3  
4  
5 UNITED STATES NUCLEAR REGULATORY COMMISSION'S  
6 ADVISORY COMMITTEE ON REACTOR SAFEGUARDS

UNITED STATES OF AMERICA  
NUCLEAR REGULATORY COMMISSION  
+ + + + +  
ADVISORY COMMITTEE ON REACTOR SAFEGUARDS  
(ACRS)  
+ + + + +  
SUBCOMMITTEE ON ESBWR  
+ + + + +  
THURSDAY  
SEPTEMBER 23, 2010  
+ + + + +  
ROCKVILLE, MARYLAND  
+ + + + +

The purpose of this meeting is to be briefed on the final SERs for Chapter 3, Design of Structures, Components and Equipment, Chapter 4, Reactors, Chapter 6, Engineering Safety Features, and Chapter 7, Instrumentation and Control Systems, and Chapter 9, Auxiliary Systems associated with the ESBWR design.

Figure 1  
Plan View of RB/FB Complex Basemat  
Extent of Uplift for Maximum Bearing Capacity (DL + Buoyancy)  
(cont'd)

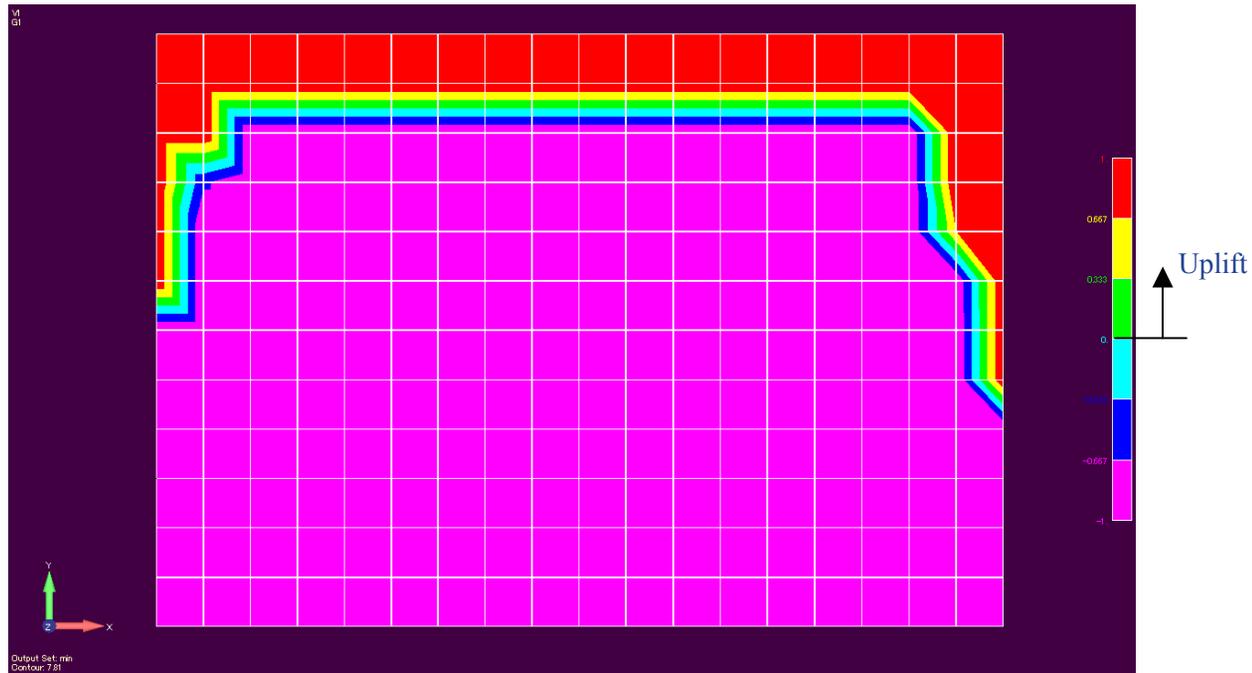
3 MR. NIOGI: They're independent. NRC RAI  
4 2.8 3.8-94. Confirmed, that a soil -bearing demand is  
5 less than the soil -bearing capacity due to static and  
6 dynamic loading conditions. Provide t he technical  
7 basis for not considering the -- during an event.  
8 Bearing and sliding calculation which uses SASSI  
9 results.

3 As shown in Figure 1, as shown in  
4 Figure 1, the extent of uplift is not extensive, and a  
5 large portion of the base mat remains in contact with  
6 the soil. GEH complied with the NRC request and  
7 filled the spectral valleys between the peaks, as  
8 shown in Figure 2. The dotted line was when the  
9 valleys are not filled on, and the solid line is when  
10 the valleys are filled in.

21 GEH used the energy balance method, which  
22 takes into account the effects of uplift in the linear  
23 response calculated by SASSI. We thus concluded that  
24 this simplified method provides a reasonable estimate  
25 using the linear analysis results on the amount of

Figure 3

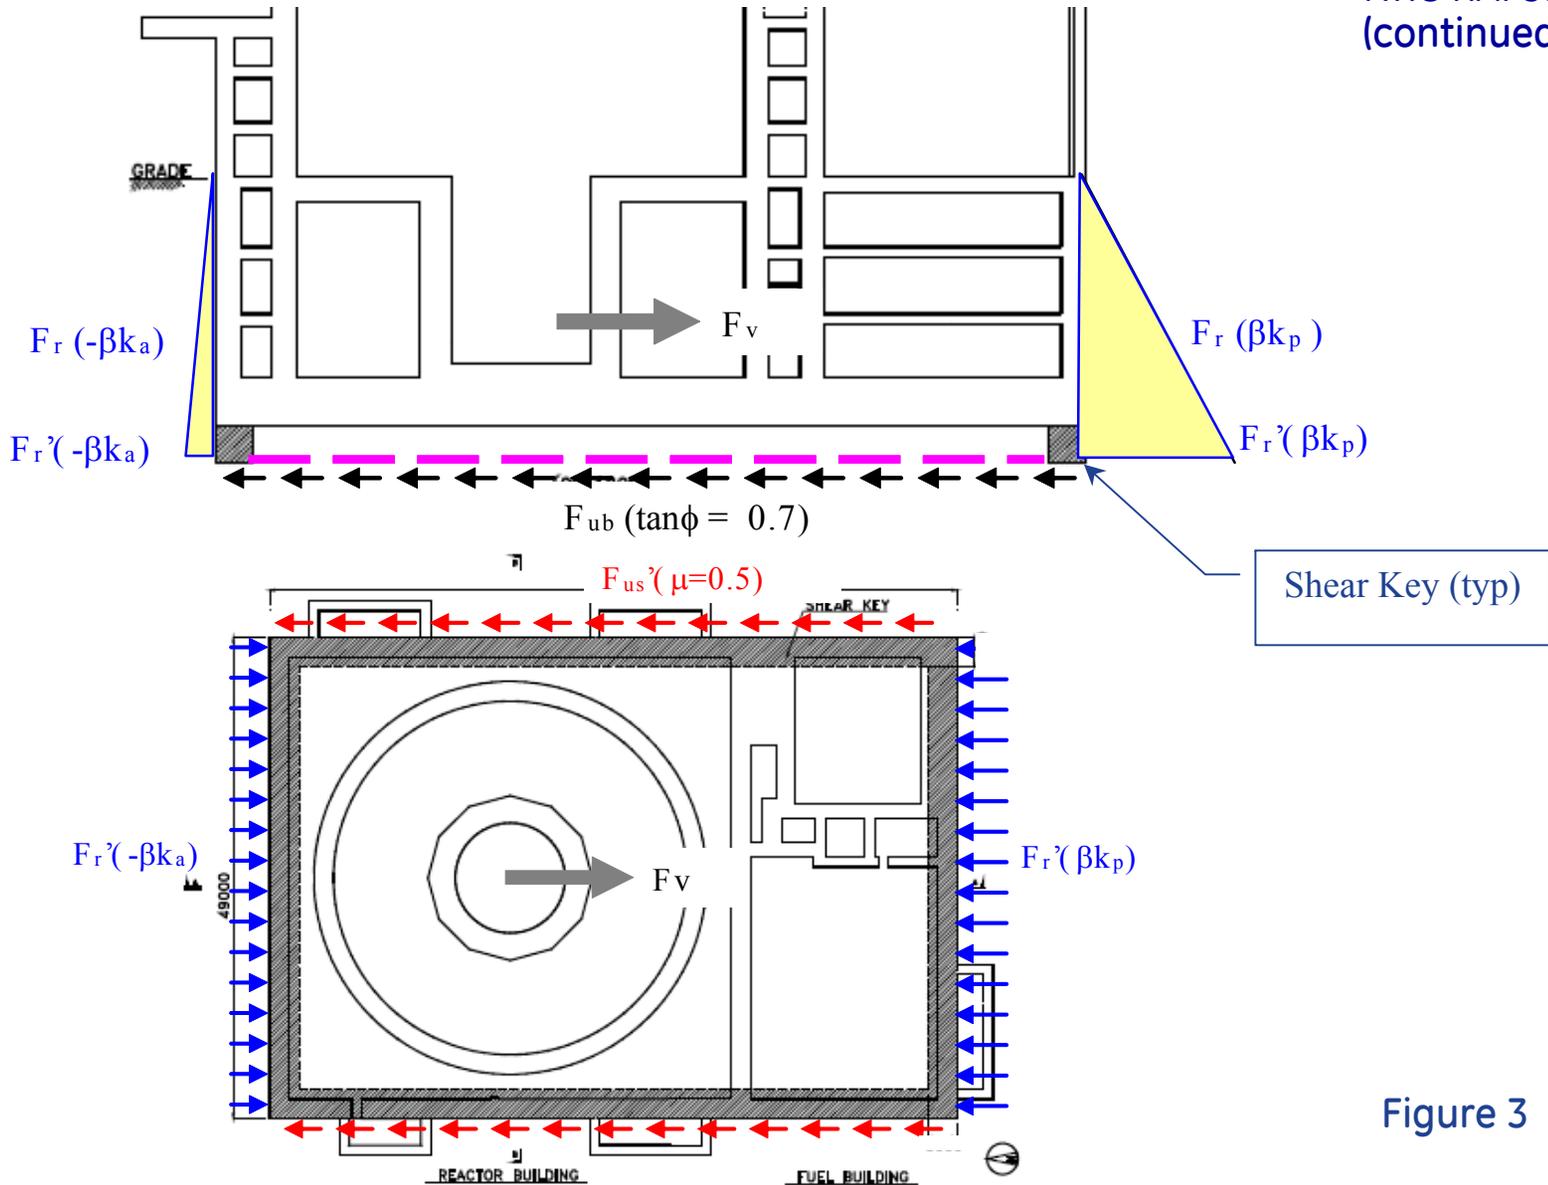
6 In this evaluation, passive pressure was  
7 needed to comply with SRP 3.8.5 requirements. GEH  
8 added shear keys to the reactor building, fuel  
9 building complex and service complex to increase the  
10 sliding resistance. See Figure 3.

12 CHAIRMAN CORRADINI: So these were added?

13 I just want to understand. These were added because,  
14 if I remember back last time we discussed this, there  
15 was -- the staff wanted you to look at variation in  
16 the sliding coefficient, and these were added to add  
17 extra margin to -- that even if the sliding  
18 coefficient was lower, you still met the requirement?

9 CHAIRMAN CORRADINI: The applicant stated  
10 in the response to RAI 3.8-96 that by roughening the  
11 top surface of the mud mat concrete, friction  
12 resistance is increased between the mud mat and base  
13 mat, added troughs in the soil under the mud mat to  
14 increase shear resistance.

23 MR. NIOGI: By roughening the surface face  
24 of the mud mat concrete, friction resistance is  
25 increased between the mud mat and base mat. Added

4 Static coefficient of frequency of .7  
5 beneath the base mat and the reduced coefficient of  
6 friction of 0.5 for the vertical surface of the wall  
7 is adequate to provide sliding stability. Additional  
8 reinforcement was added to the vertical walls to  
9 resist passive pressure, to increase the friction  
10 relation between the base mat, mud mat and soil.

- It was confirmed that the Seismic Category I structures meet the sliding stability requirements of the SRP 3.8.5 by considering passive pressure resistance, resistance due to friction at the bottom of the basemat and along the vertical surfaces of the walls.
- GEH used reduced coefficient of friction in the vertical walls to calculate friction resistance due to passive pressure. In this evaluation passive pressure was needed to comply with the SRP 3.8.5 requirement.
- GEH added shear keys to the RB/FB complex and FWSC to increase the sliding resistance. See Figure 3.
- By roughening the top surface of the mudmat concrete, friction resistance is increased between the mudmat and basemat. Added troughs in the soil under the mudmat to increase shear resistance.
